# Work Order ID 68279

Item ID:	D3391-023	Accept		Setup	Start	
Revision ID:					Stop	
Item Name:	Mid Tube Assembly					
Start Date:	4/11/2011	Start Qty:	1.00			
Required Date:	4/15/2011	Req'd Qty:	1.00			
Reference:

DRAWING NO. D3391	TITLE 412 FLOAT SKIDTUBE	REV. H	<b>DART AEROSPACE USA, INC ENGINEERING ORDER</b>		D.E.O. NO. D3391-H-1	SHEET NO. SHEET 1 OF 1	SCALE NTS
DRAWN <i>CP</i>	CHECKED <i>h</i>	MFG. APPR. <i>M</i>	APPROVED <i>MP</i>		DE APPR. <i>MP</i>		
DATE 09.09.23	DATE 04.04.24	DATE 09/09/25	DATE 09/09/30		DATE 09/09/30

**D3391-041 FLOAT SKIDTUBE ASSEMBLY PARTS LIST**

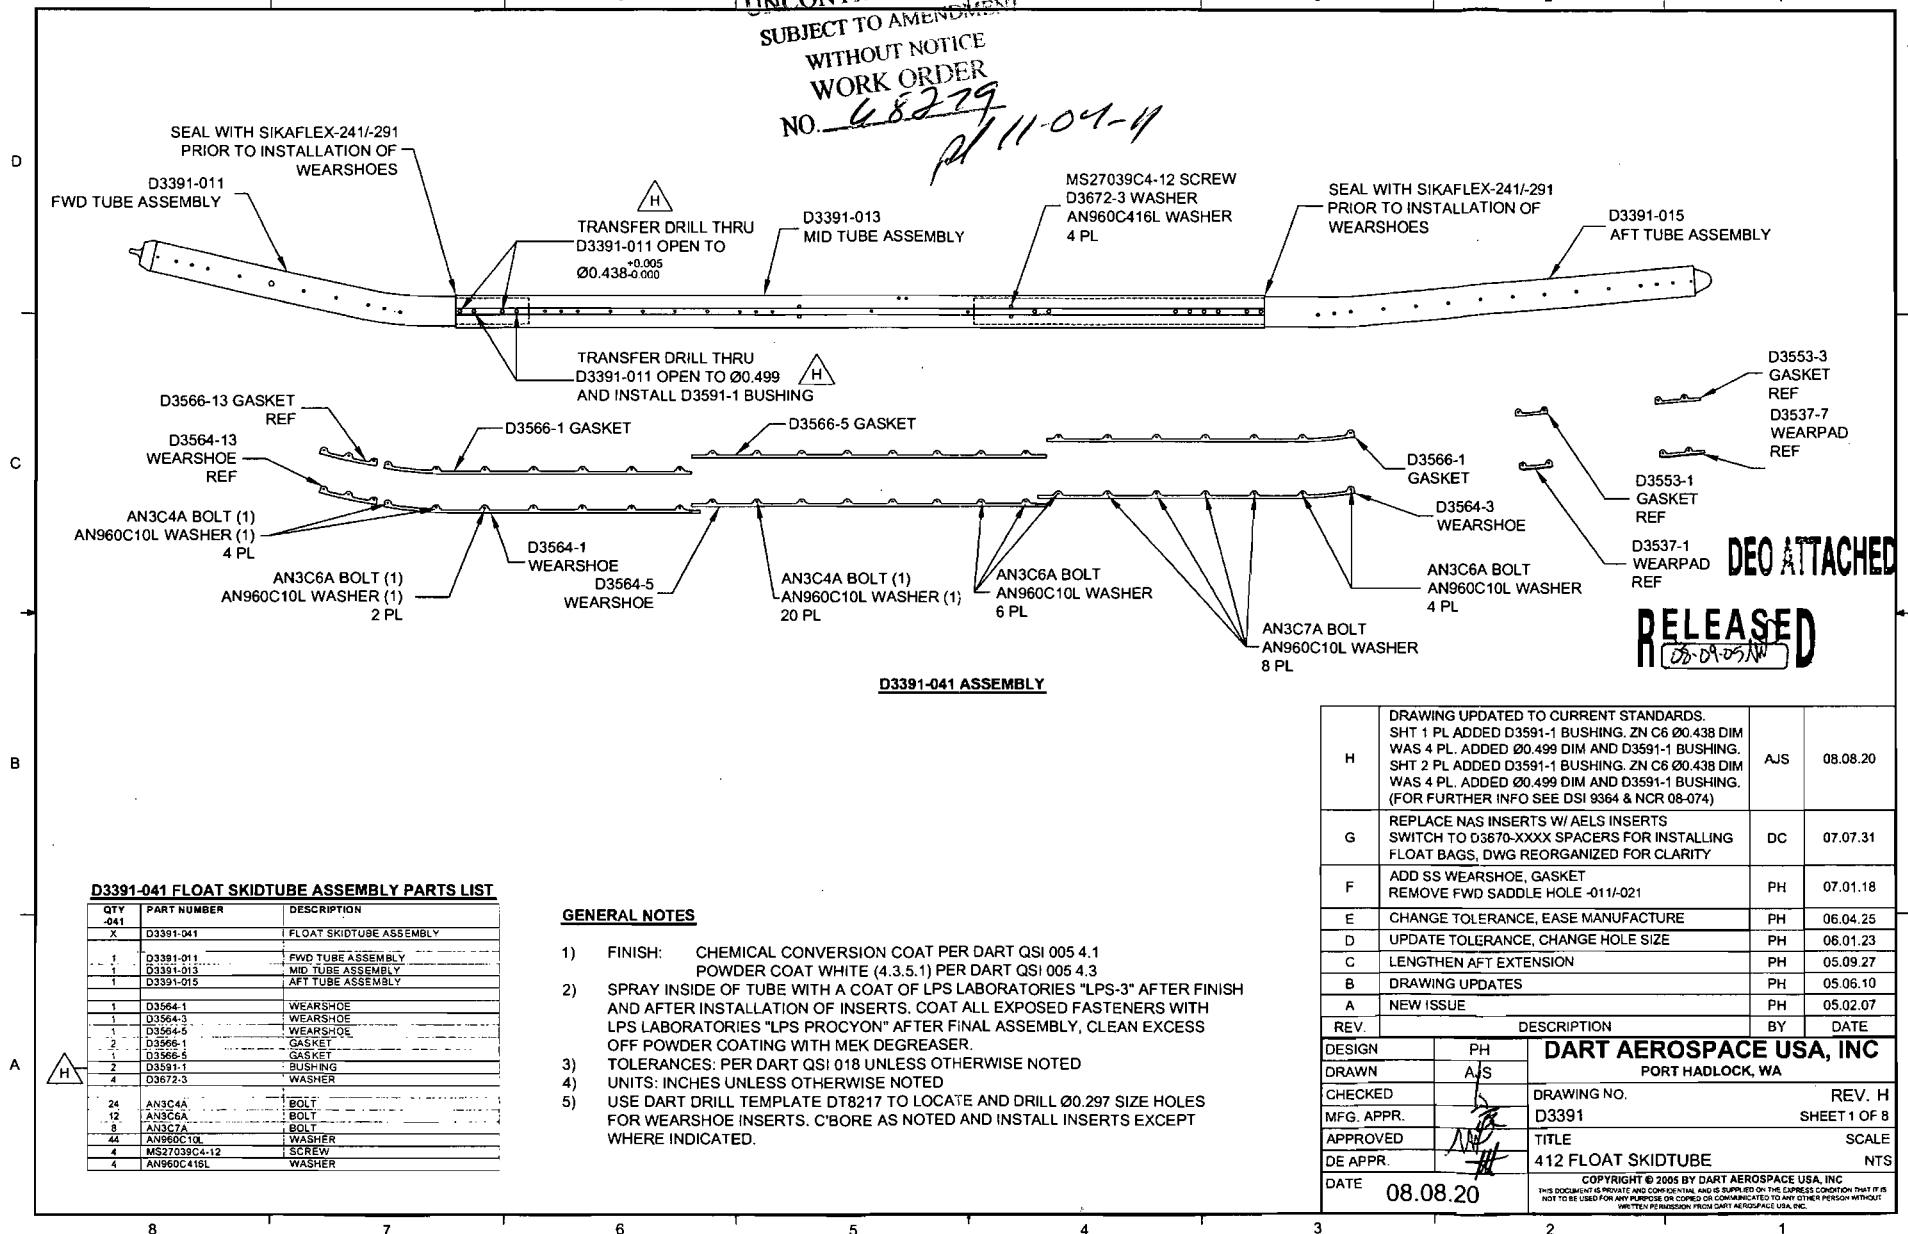
LPS-3 IS NO LONGER USED DURING ASSEMBLY OF D3391-041/-043 SKIDTUBES.

AMEND NOTE 2 OF D3391-041/-043 SKIDTUBE ASSEMBLIES (ZN A6-1, A6-2) AS FOLLOWS:

- 2) ~~SPRAY INSIDE OF TUBE WITH A COAT OF LPS LABORATORIES "LPS-3" AFTER FINISH~~  
~~AND AFTER INSTALLATION OF INSERTS. COAT ALL EXPOSED FASTENERS WITH~~  
 LPS LABORATORIES "LPS PROCYON" AFTER FINAL ASSEMBLY, CLEAN EXCESS  
 OFF POWDER COATING WITH MEK DEGREASER.
